**CENTRAL AVENUE, HAYES**

**STAGE 1 ROAD SAFETY AUDIT REPORT**

**PROPOSED SITE ACCESS – REVISED  
LAYOUT**

Project:	Lidl, Central Avenue, Hayes – Revised Site Access Layout
Client:	Gateway TSP
Document:	Stage 1 Road Safety Audit
RKS Associates Ref:	VRP465 - 01
Issue date:	17 <sup>th</sup> July 2014
Status:	Final
Authorised by:	VP

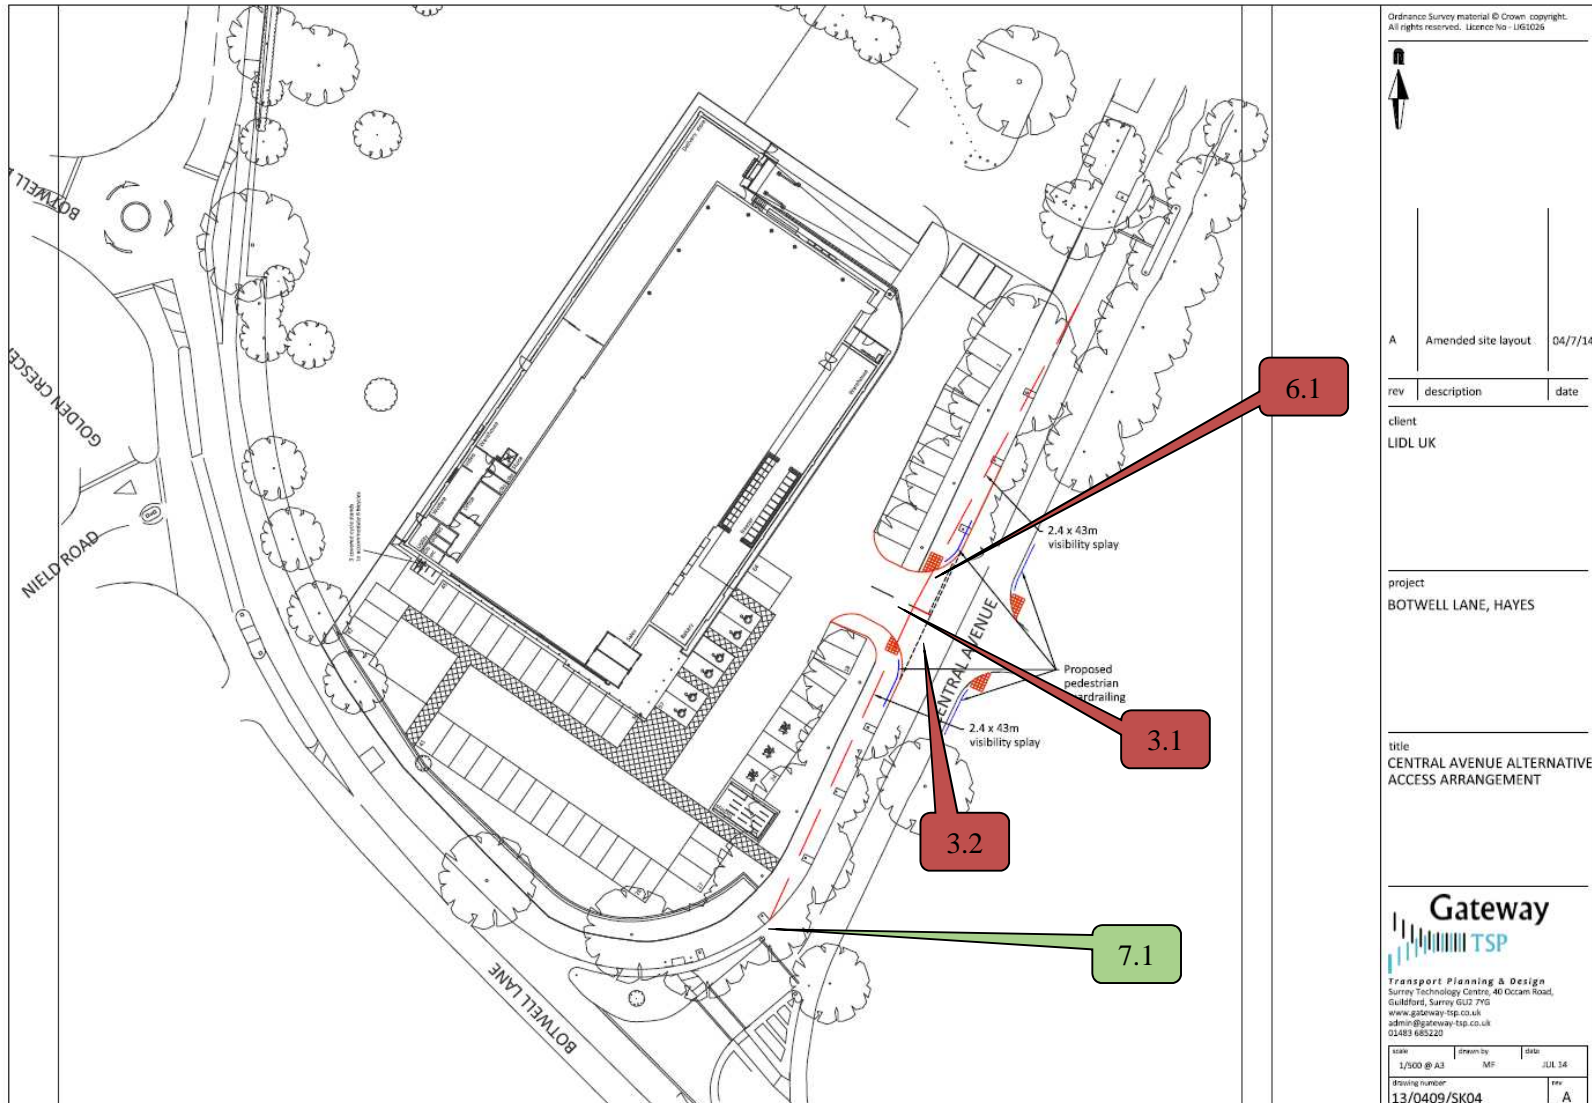
No details relating to longitudinal or cross sections through the proposed site access have been provided. Whilst it is not possible for the Audit Team to ascertain whether or not any safety issues will arise, there is concern that uneven surface may cause a hazard that results in injury to road users.

Provide longitudinal and cross sections through the proposed access and section of carriageway between Central Avenue and the proposed store access as part of detailed design, as appropriate, for the purposes of Stage 2 RSA.

Details of surface water drainage and other service diversions have not been provided at this time and it is therefore not possible for the Audit Team to ascertain whether or not there will be any safety implications. None were apparent during the site inspection.

Provide details of surface water drainage and any service diversions associated with the new accesses as part of detailed design, as appropriate, for the purposes of Stage 2 RSA.

The proposed store access will require the removal of an existing street lighting column, no details relating to street lighting have been provided. Poor carriageway lighting may increase the risk of vehicle collisions during the hours of darkness.

Street lighting analysis should be undertaken at the detailed design stage, for the Stage 2 RSA; if necessary a new street lighting column should be provided in order to maintain appropriate levels of illumination of the carriageway.

Item No.	Audit Team Recommendation(s)	Designer's Response
3.1	Provide longitudinal and cross sections through the proposed access and section of carriageway between Central Avenue and the proposed store access as part of detailed design, as appropriate, for the purposes of Stage 2 RSA.	Agreed – longitudinal and cross sections will be provided as part of the detailed design, for the purposes of Stage 2 RSA.

3.2	Provide details of surface water drainage and any service diversions associated with the new accesses as part of detailed design, as appropriate, for the purposes of Stage 2 RSA.	Agreed – details of surface water drainage and any service diversions will be provided as part of the detailed design, for the purposes of Stage 2 RSA.

4.1	N/A	
5.1	N/A	
6.1	Street lighting analysis should be undertaken at the detailed design stage, for the Stage 2 RSA; if necessary a new street lighting column should be provided in order to maintain appropriate levels of illumination of the carriageway.	Agreed – details of street lighting will be provided as part of the detailed design, for the purposes of Stage 2 RSA.
